The Consortium for Risk Evaluation with Stakeholder Participation III

RE: CRESP Review Team Letter Report 7 – PJM Vessels

The CRESP Review Team¹ for issues related to the Waste Treatment Plant (WTP) has been asked to provide on-going support to the Department of Energy (DOE) Office of River Protection (ORP) through review of the technical resolution by DOE and its contractors of several of the External Flowsheet Review Team (EFRT) major issues. This letter report addresses the EFRT issue M-3 Pulse Jet Mixer (PJM) performance, stated as

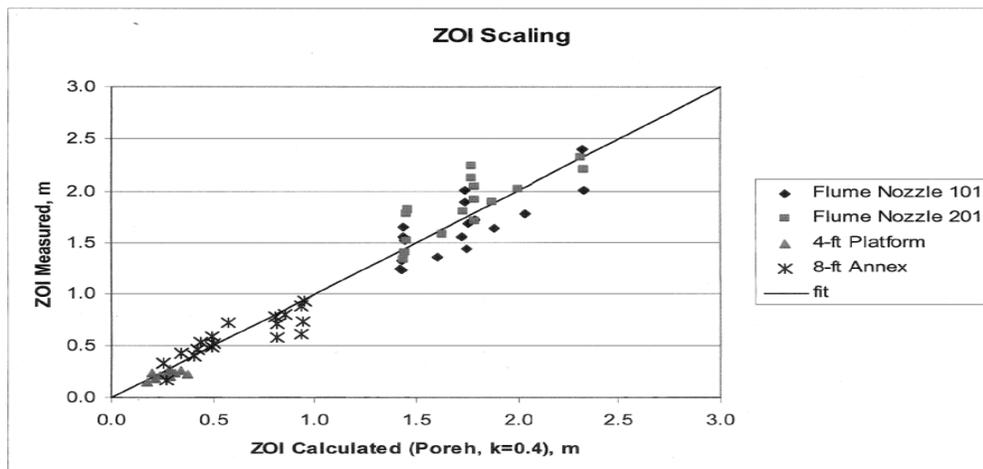
In Paper 2, Poreh uses the Shields model to calculate the shear stress for particle mobilization which is then combined with the flow field analysis of Paper 1 to obtain an effective clearing radius (ECR), which is considered by BNI to be equal to the ZOI (last paragraph, page 8, CCN: 217414). The accuracy of this correlation with an empirically adjusted constant is shown below for non-cohesive (sand) particulate data (page 9, CCN: 217414). The figure below is Figure 2 of CCN: 217414 and also appears in every other vessel assessment.

On the graph, at large ZOI (greater than 1.5 m) for flume data and for a given set of test data, the Poreh/Shields combined correlations predict, e.g about 1.7 m, while data range from about 1.4 to 2.3 m. At low ZOI (8 ft annex) Poreh/Shields predicts about 0.9 m while data show about 0.6 to 0.9 m and therefore, is not conservative at the smaller scale. So as a rough estimate, we can say that the model correlates the data to within 50%. Contrast this with the statement that follows (from page 9): “Thomson (2010) correlated these data, see Figure 2, and found that the

The statement that the correlations differ by a factor of 8, and that the Poreh correlation coefficient for this of 1.1963 (page 11 of CCN: 217414) is within that range, does not provide a high degree of confidence. Clearly, smaller values of C are conservative, and larger values are not. That the Poreh correlation yields larger values than two of the other reported values indicates that it is not the most conservative assumption, especially compared to the value of 0.747. In fact, using a value of 1.1963 rather than 0.747 leads to an area of bottom cleaning that is 2.5 times larger than would be calculated using 0.747. This discrepancy needs to be resolved via larger scale tests.
